Florida Power & Light
Topical Quality Assurance Report
Change Summary
June, 1993

Summary of changes to the Florida Power and Light Topical Quality Assurance Report (FPLTQAR 1-76A)

TOPICAL QUALITY ASSURANCE REPORT	REV. 6A
TURKEY POINT NUCLEAR SITE ORGANIZATION FIGURE 1-2 APPENDIX A	8/17/92
	PAGE 1 OF 1

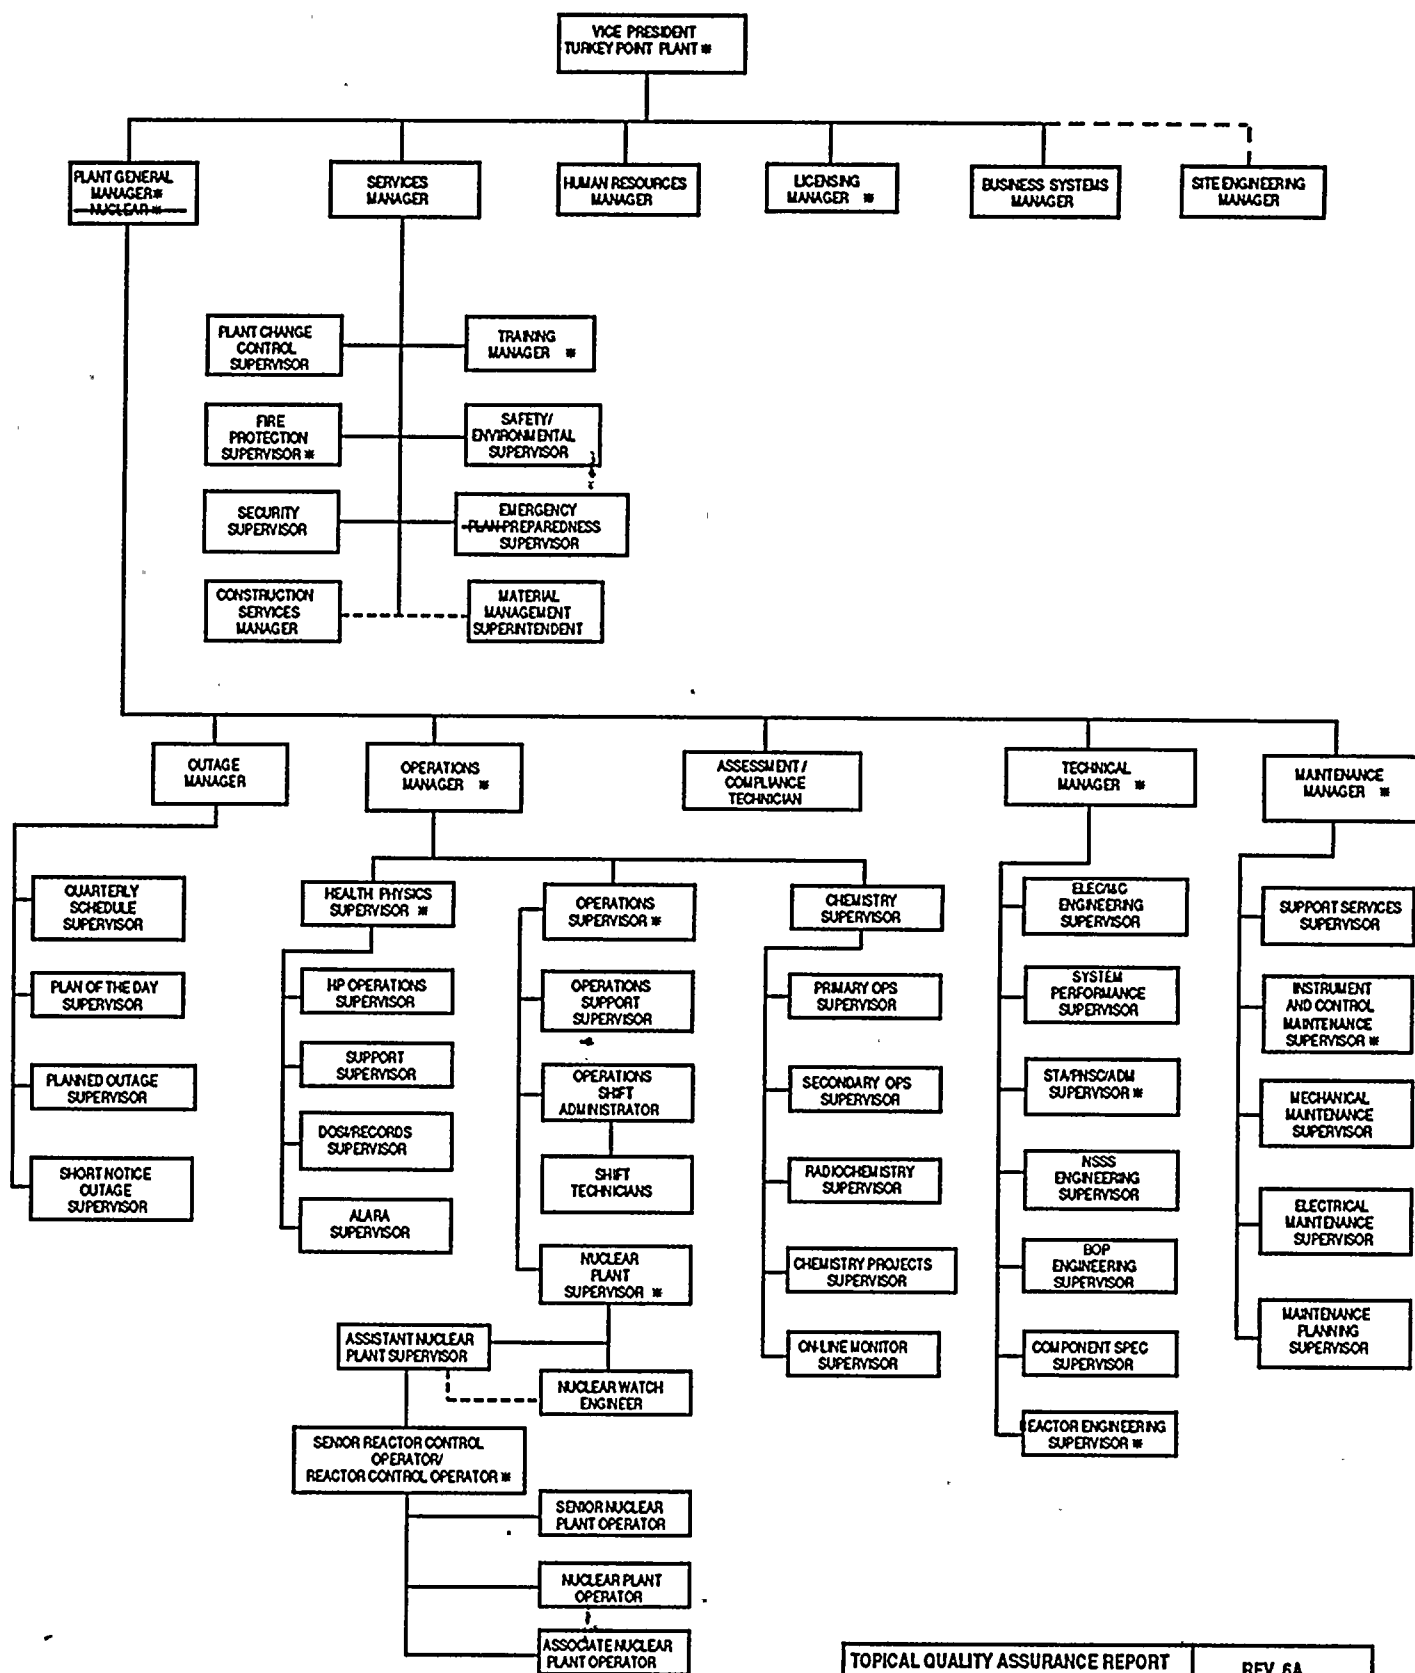
13. TQR Appendix A Figure 1-2: Turkey Point Nuclear Site Organization Rev. 5 Change Notice No. 39

This change notice updates titles for the PTN site organization.

TOPICAL QUALITY ASSURANCE REPORT	REV. 19
ORGANIZATION OF DEPARTMENTS AFFECTING QUALITY FIGURE 1-1 APPENDIX A NUCLEAR DIVISION	8/28/92
	PAGE 1 OF 2

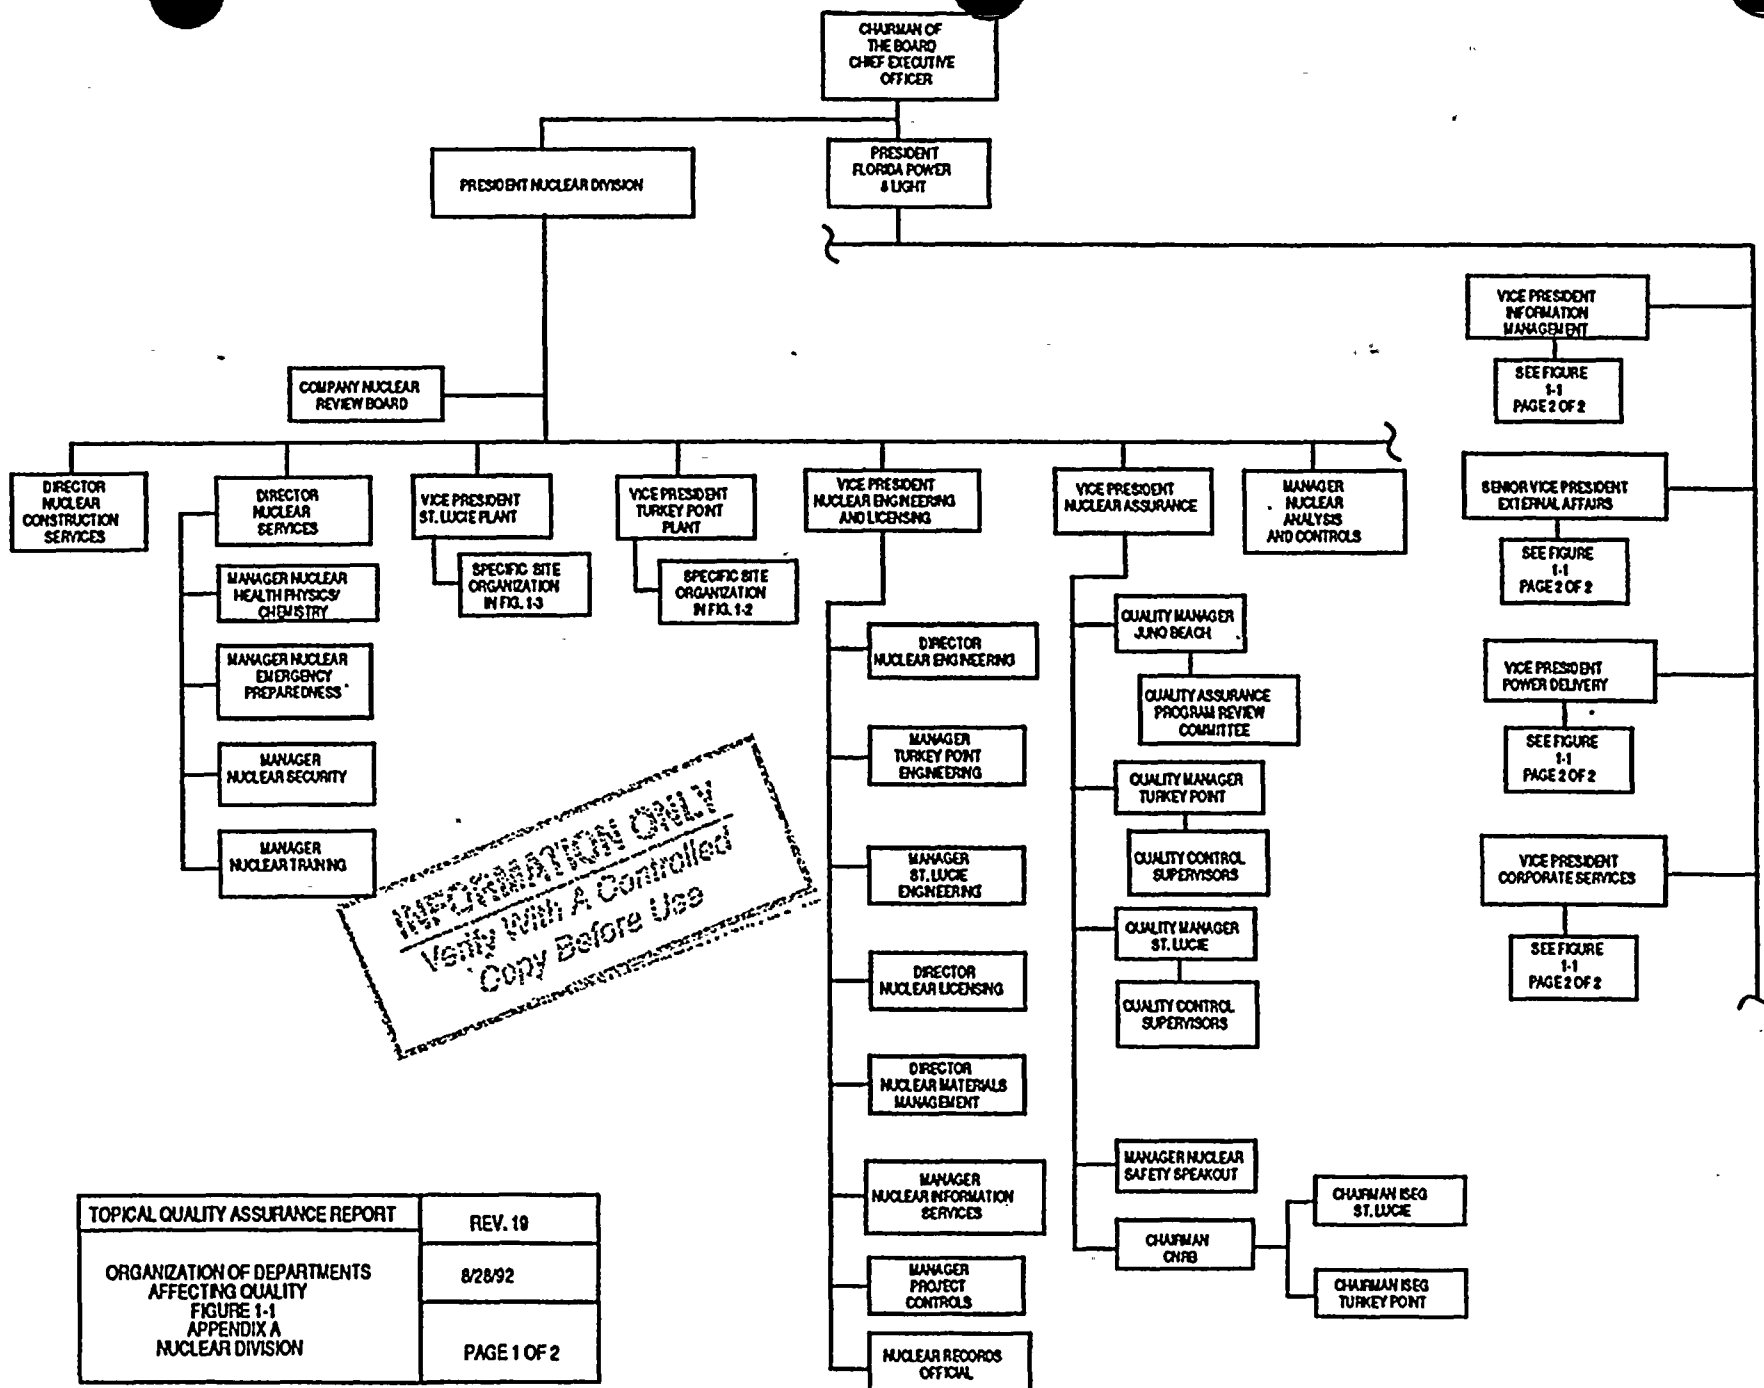
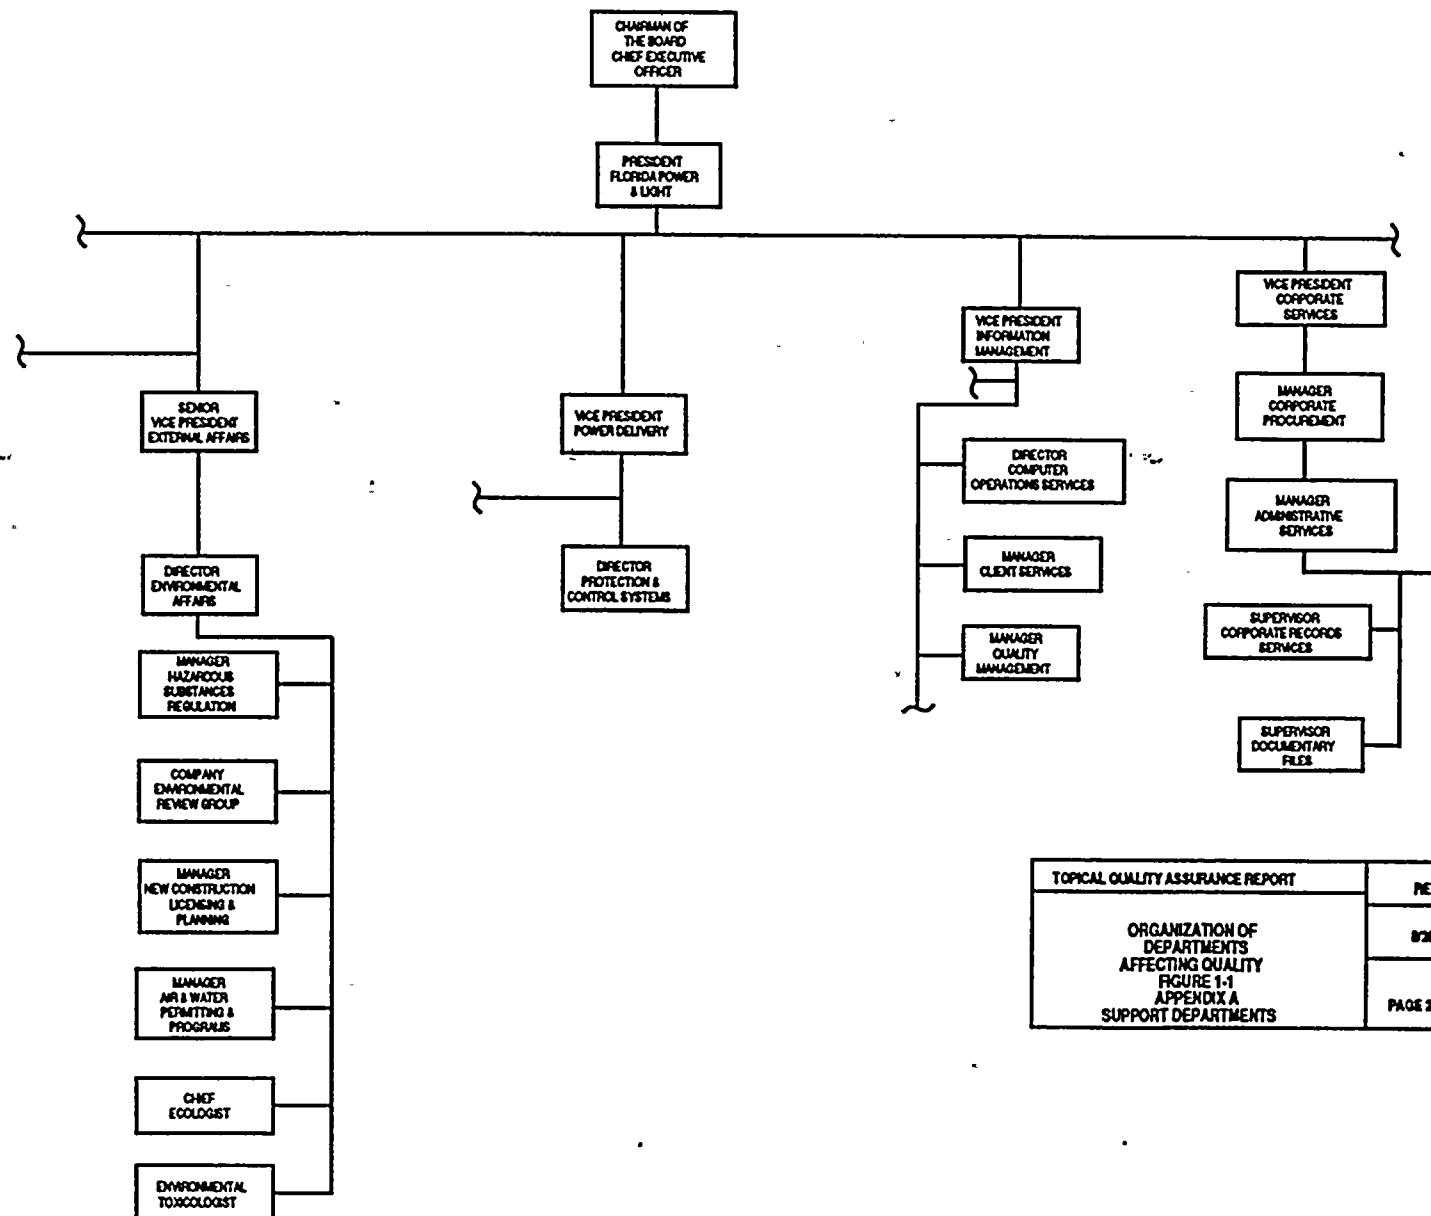
11. TQR Appendix A Figure 1-1: Organization of Departments Affecting Quality Rev. 18 to Rev. 19

Updated to reflect changes in organizational reporting relationships and titles resulting from changes to TQR 1.0. Rev. 21 to Rev. 22.

TOPICAL QUALITY ASSURANCE REPORT	REV. 20
ORGANIZATION OF DEPARTMENTS AFFECTING QUALITY FIGURE 1-1 APPENDIX A NUCLEAR DIVISION	2/5/93
	PAGE 1 OF 2

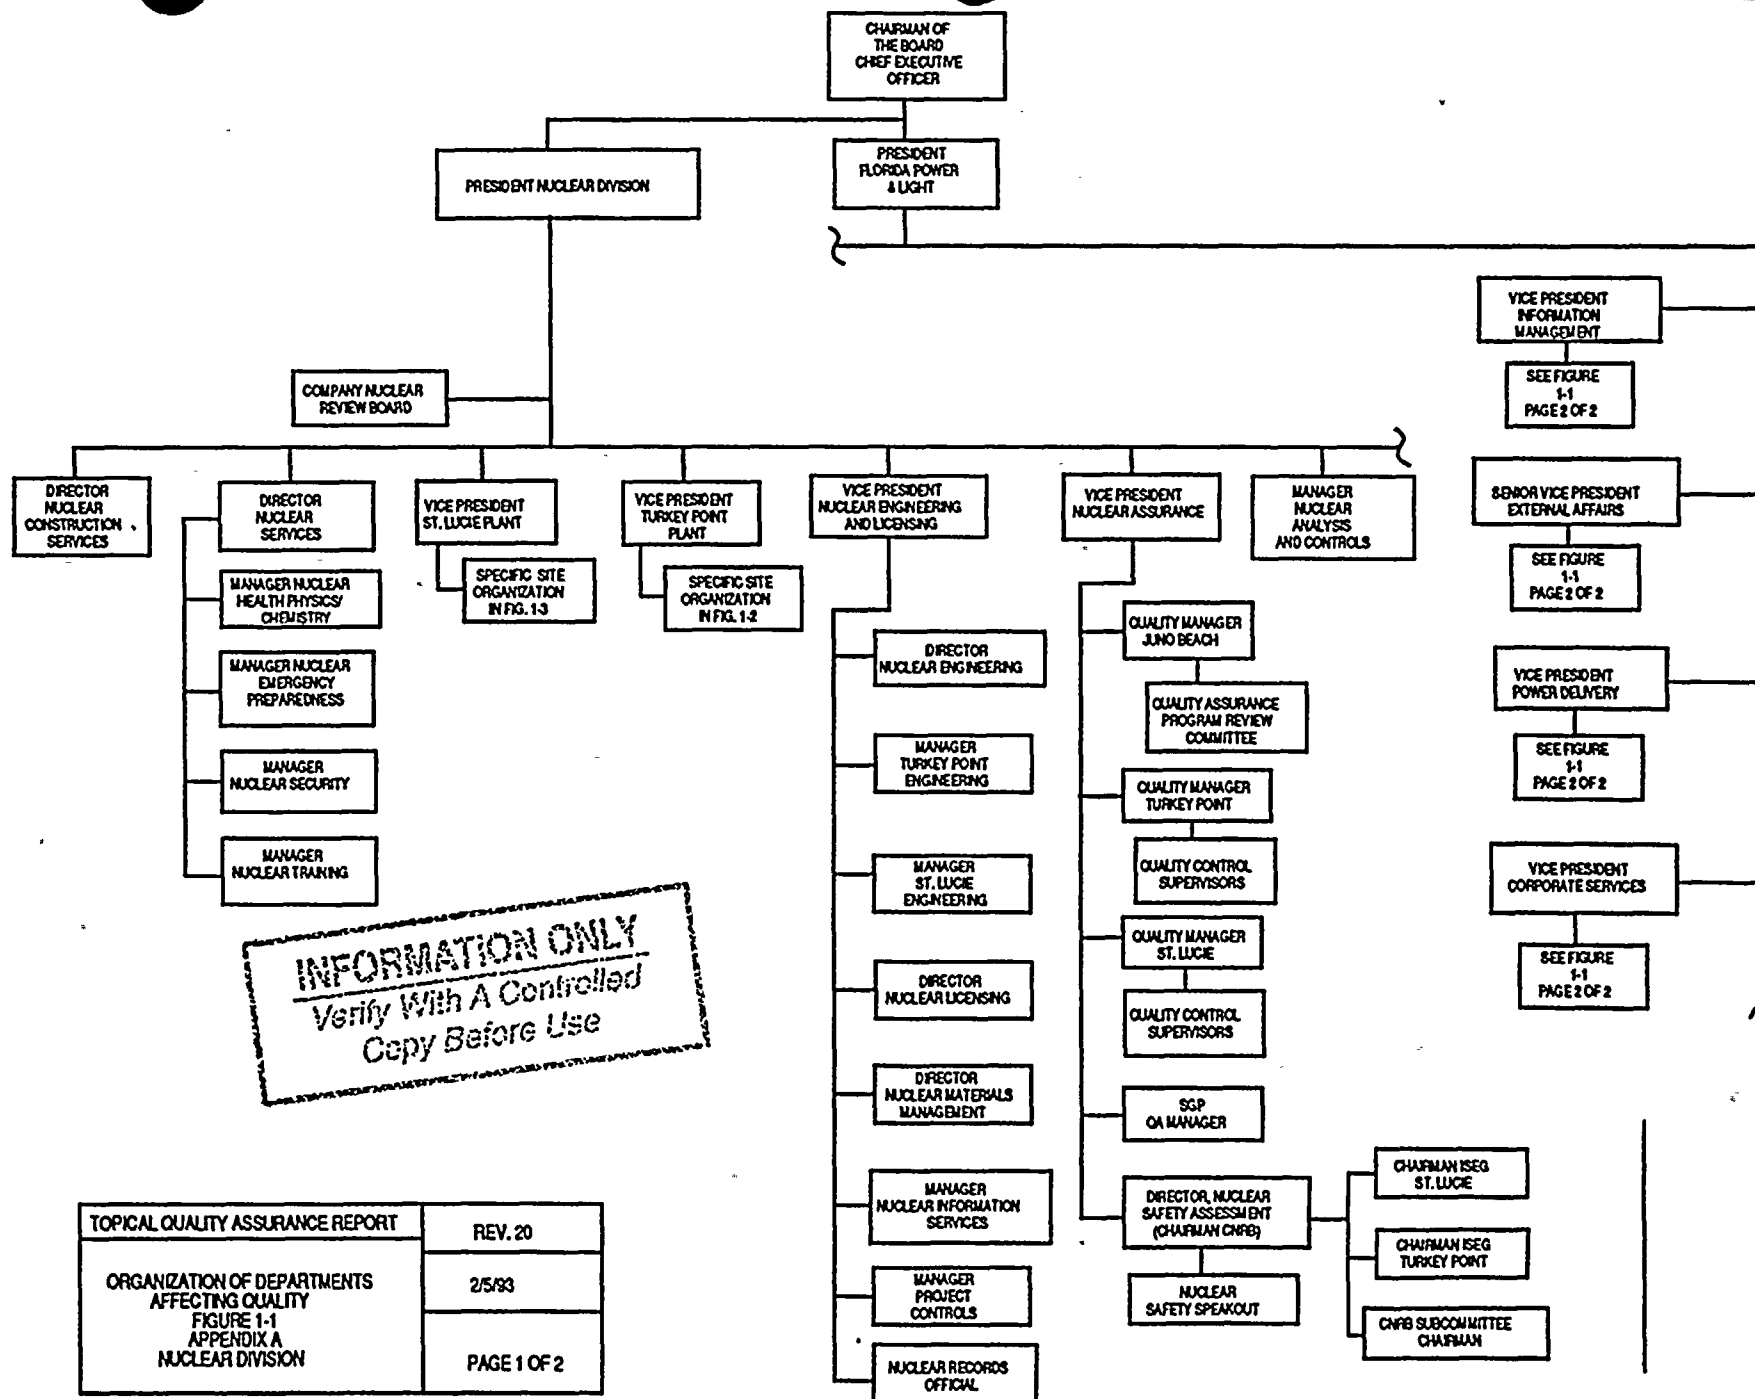
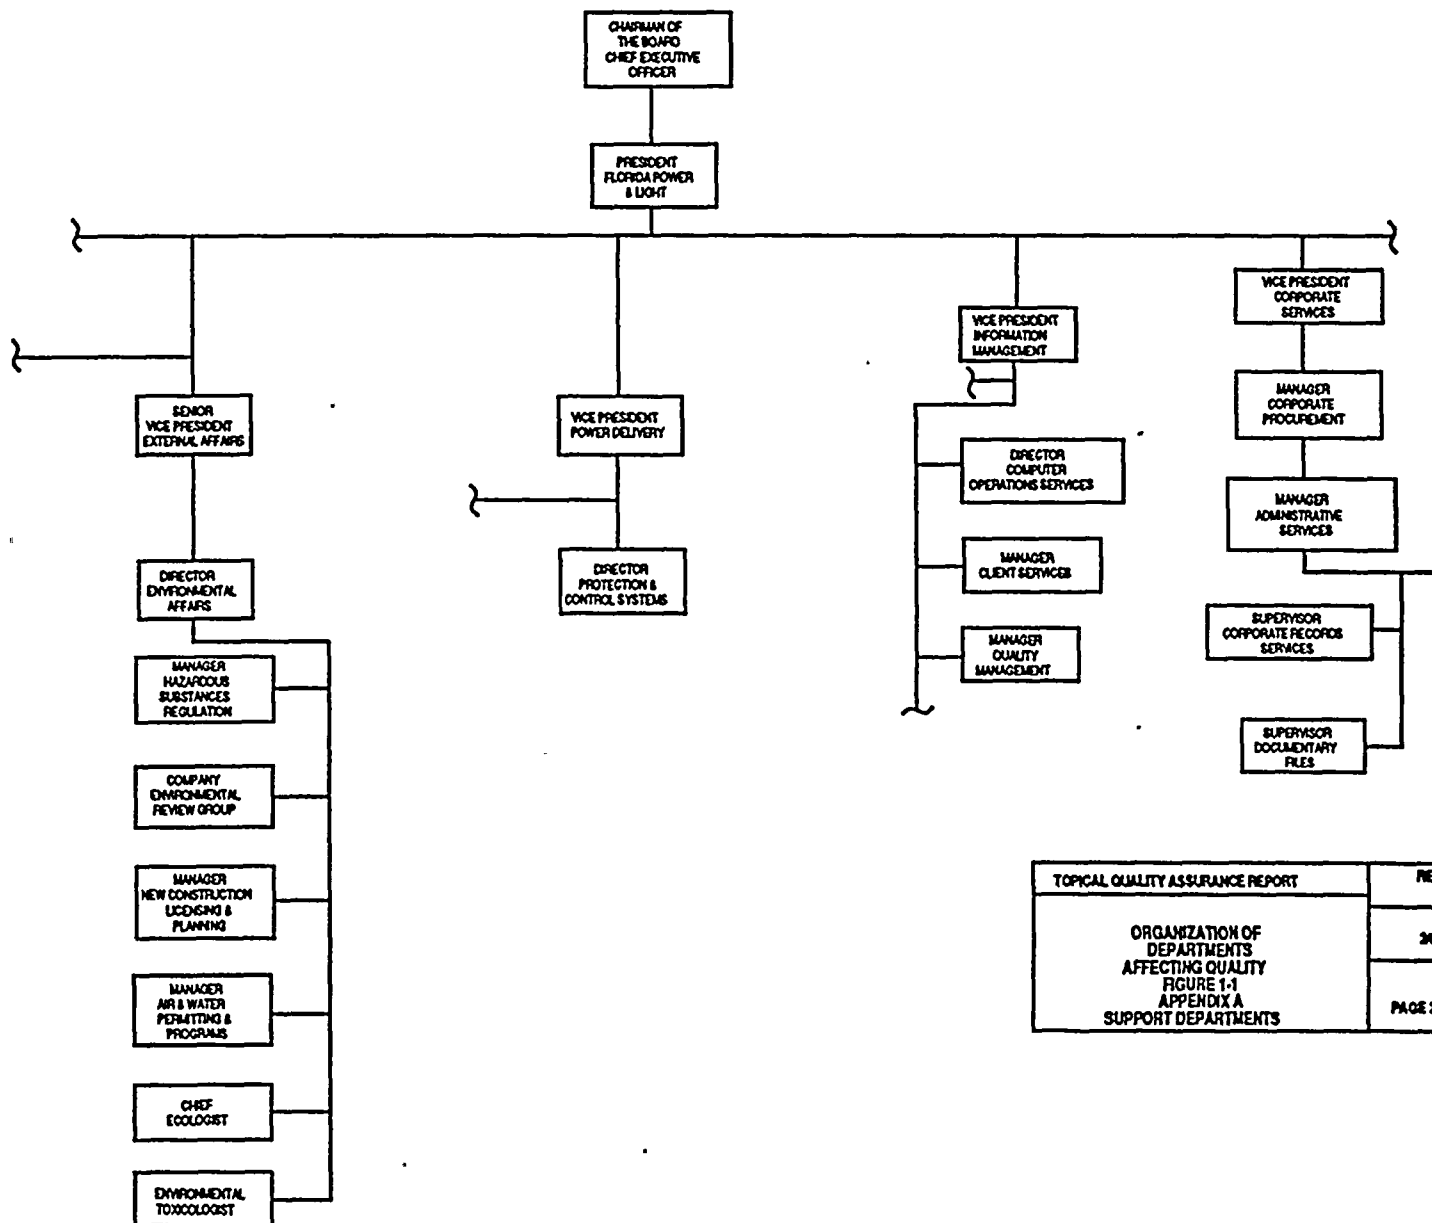
12. TQR Appendix A Figure 1-1: Organization of Departments Affecting Quality Rev. 19 to Rev. 20

This revision updates organization and titles for the Nuclear Assurance Department resulting from changes to TQR 1.0 Rev. 23 to Rev. 24.
